ARCHITECT'S ADDENDUM

Addendum Number: 008

RE: KANE COUNTY - Multi-Use facility

Subject: Addendum No. 008 to the Construction Documents for the Kane County Multi-Use Facility.

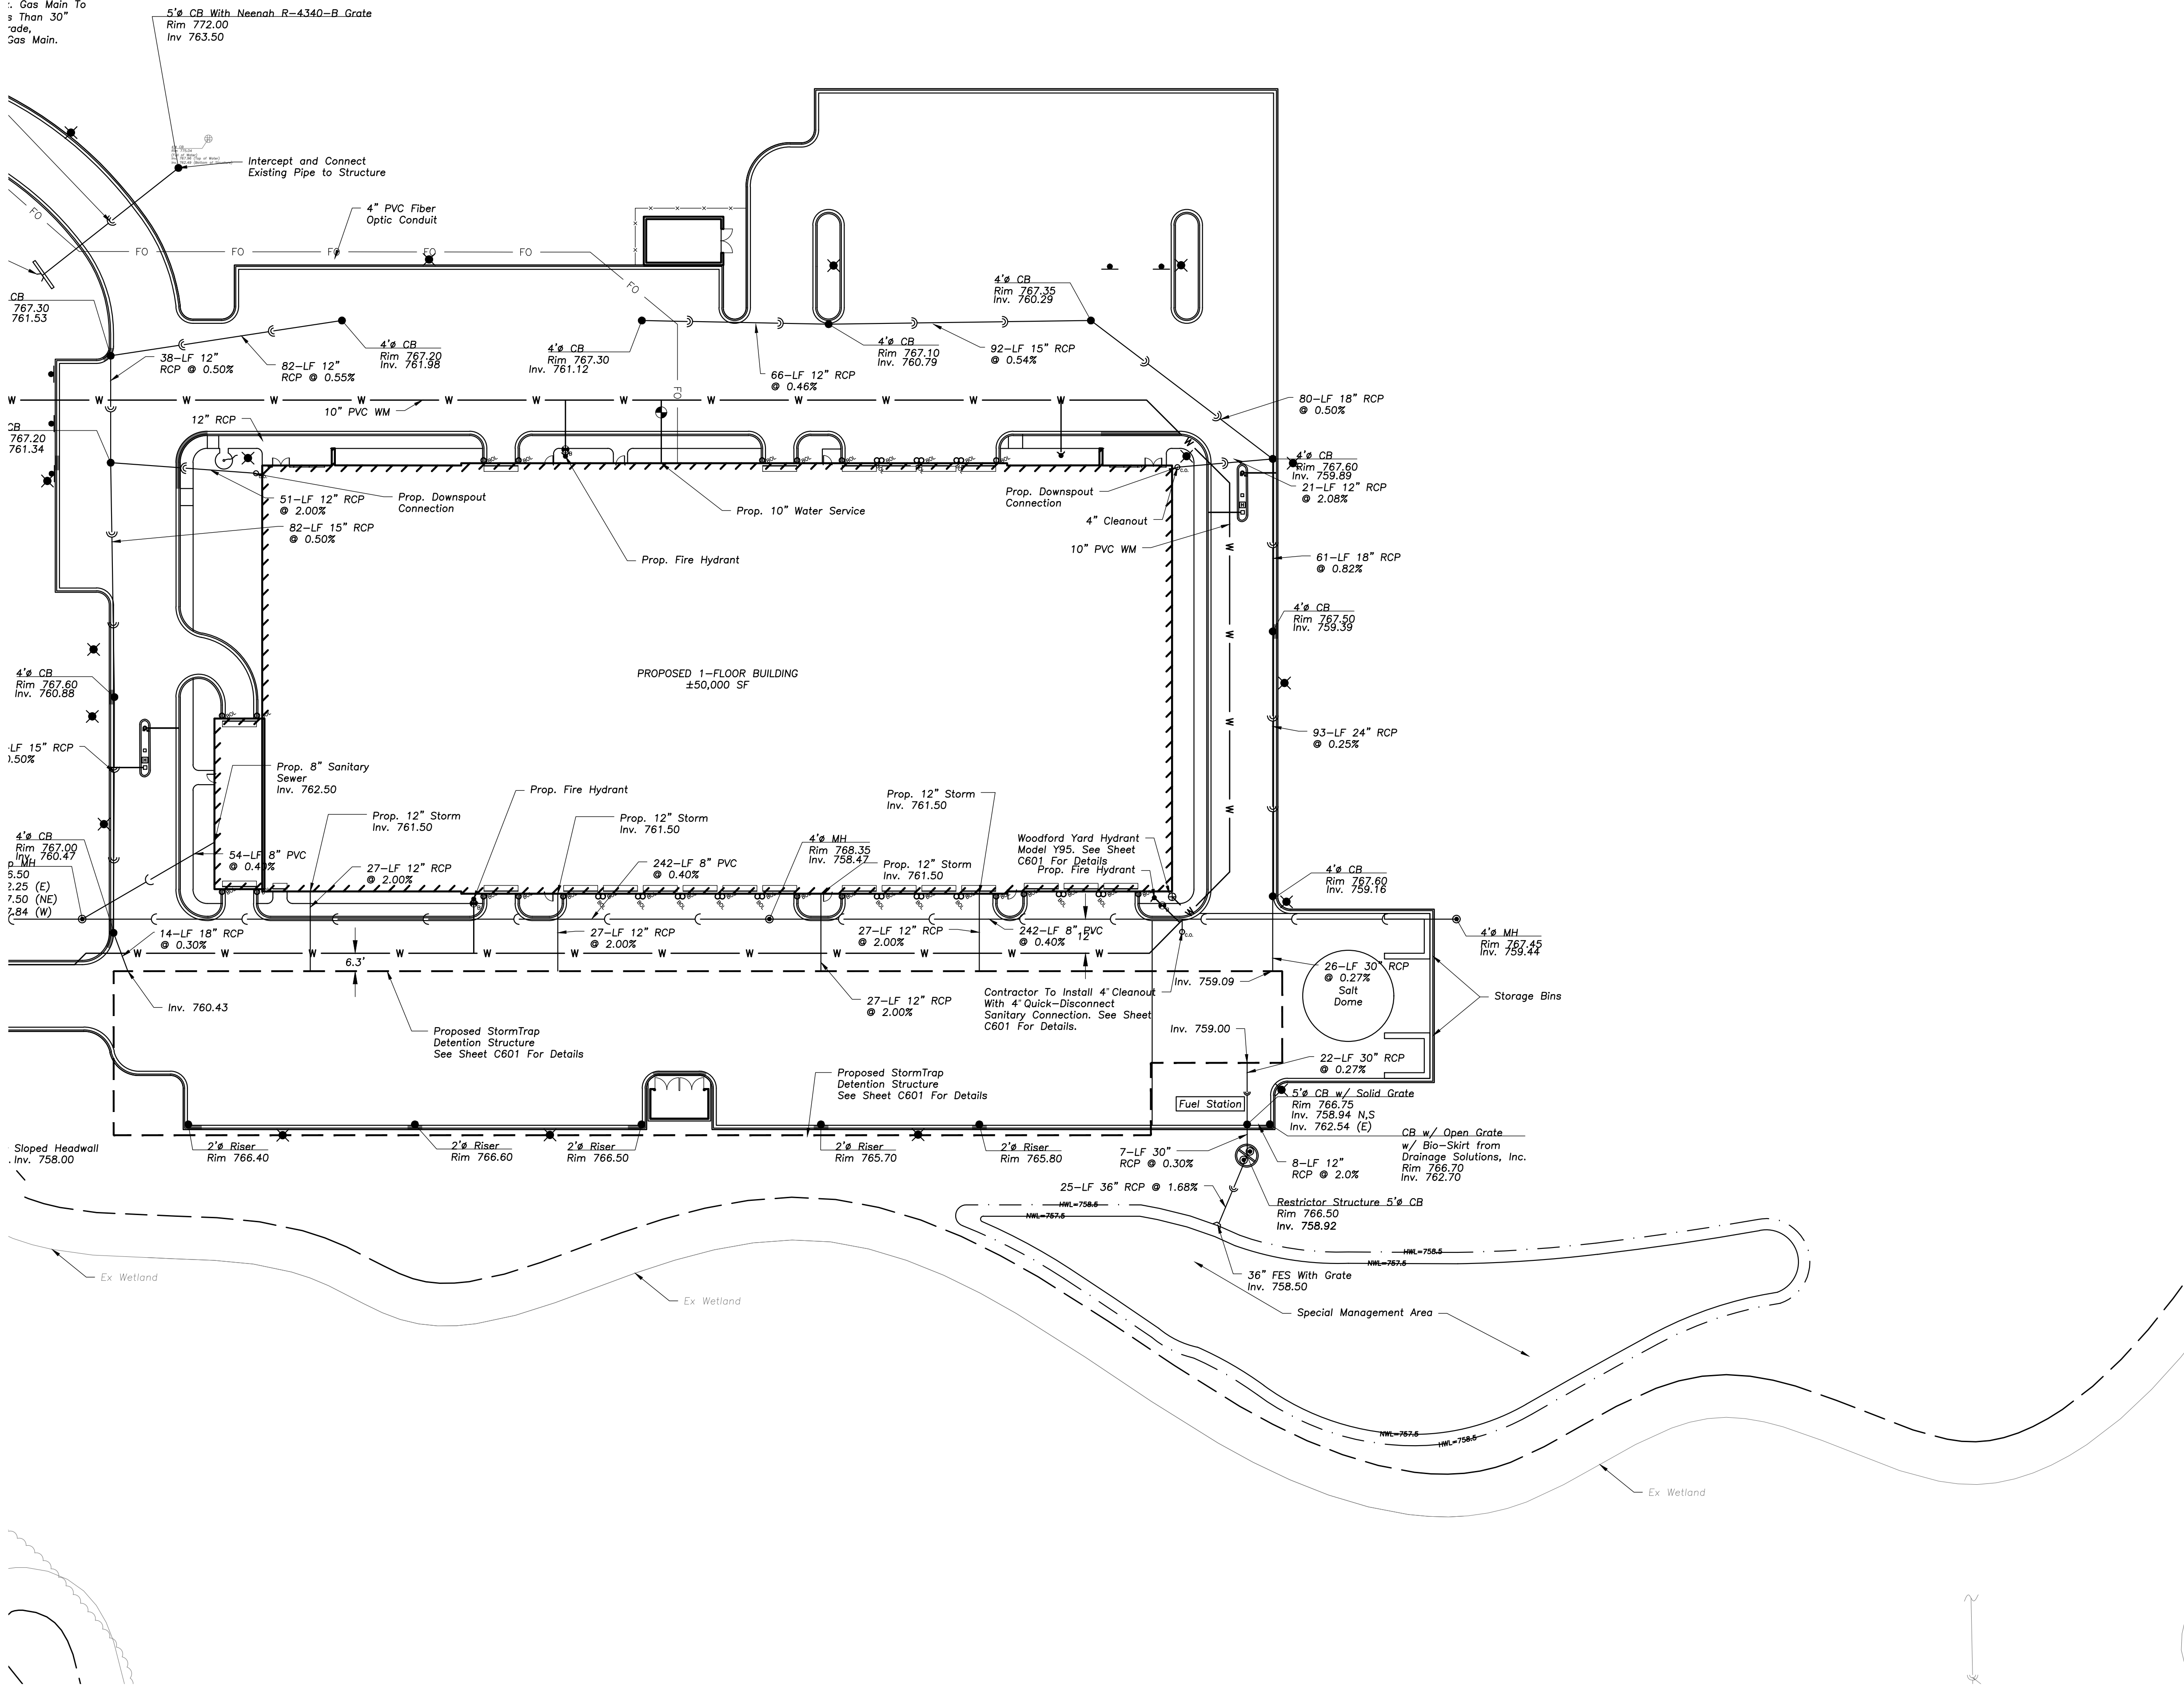
RFI NO.	CONTRACTOR	CONTRACTOR'S QUESTION	DRAWING REFERENCE	SPEC REFERENCE	DATE REC'D.	DISCIPLINE	DATE RETURNED	RESPONSE
180	IHC Cinstruction Companies, LLC	<p>1). Addendum #5 Earth Moving specification indicates that the owner is hiring the Geotechnical Testing Agency, but Contract Drawings S2.1 Note 5 says the GC should retain the Geotech Engineer. Please confirm if owner is hiring independent testing agency for all trades (ie: excavation, concrete, masonry & steel).</p> <p>2) Drawing E3.1 has (4) exterior cameras but single line drawing E4.5 has (6) and refers to drawing E3.1 for location. Please clarify.</p> <p>3) Drawing E100 has (3) new lift gate locations but E5.1 Site Electrical and C2.0 Site Geometry only has (2). Please clarify.</p> <p>4) Site Utility Drawing C3.0 and C3.1 do not show the new electrical medium voltage utility ducts. Electrical Site Plan shows the medium voltage utility ducts but does not indicate location of tie-in. Please clarify.</p> <p>5). Please clarify on the install method. The RFI 80 I believe clarified to used 630 pcs 2'x4' in Alternate 6 and mentions direct mount, HOWEVER, Armstrong has different ways to direct mount and the specs say to have a "C-40" mounting (someone may not catch this). C-40 mounting is using a 1-1/2" furring along with an infill of 2-1/2" batts insulation in cavity. Obviously a lot more expensive than just what one would think is "direct mount". Note Armstrong calls all of the various mounting "direct mount", but they vary in whether or not there is a backer/insulation/furring, etc....and to different thicknesses</p> <p>6). There are numerous mentions, on the Civil Drawings, of details shown on sheet C601. I cannot find sheet C601.Please provide.</p>	<p>Memo 05.R1 - revised and included herewith</p> <p>C6.0 and C6.1 - revised and included herewith</p>		01.16.20	Arch / Electrical / Civil	01.17.20	<p>1). Refer to response for item #22 in Clarification Log, addressed in Addendum 5, issued on 01.13.20</p> <p>2). Refer to revised Memo 05.R1 Security Camera Requirements Revision 01, included herewith.</p> <p>3). There are three new lift gate locations but only two new lift gate systems. The lift gates east and west of the proposed building are new. The equipment for the lift gate in the existing ring road should be the relocated existing equipment from the existing barrier gate 375' north of the site. The old equipment and curb should be removed and the roadway patched.</p> <p>4). Duct work will be needed from the building to those gates.</p> <p>5). Bid as per contract documents.</p> <p>6). While the content on C6.0 and C6.1 has not changed, the legibility of the sheets has been improved. Sheets C6.0 and C6.1 have been reissued with this adendum.</p>
